Difference between 2610 and 2600

Part #: MM8430-2610B/MM8430-2600B

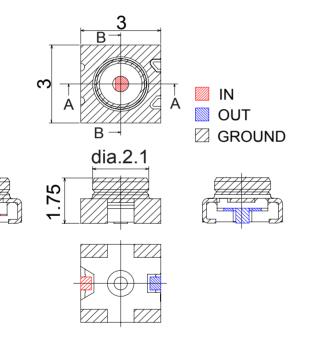
Change Point

Resin Material.

PPS

MM8430-2600*

<u>LCP</u>

MM8430-26**10***

• Improved heat resistance in reflow.

Peak Temp. 260 C ____

270°C

- Same size and construction.
- Identical electrical performance.
- Same land and solder stencil size are available.
- Same measurement probes are available.
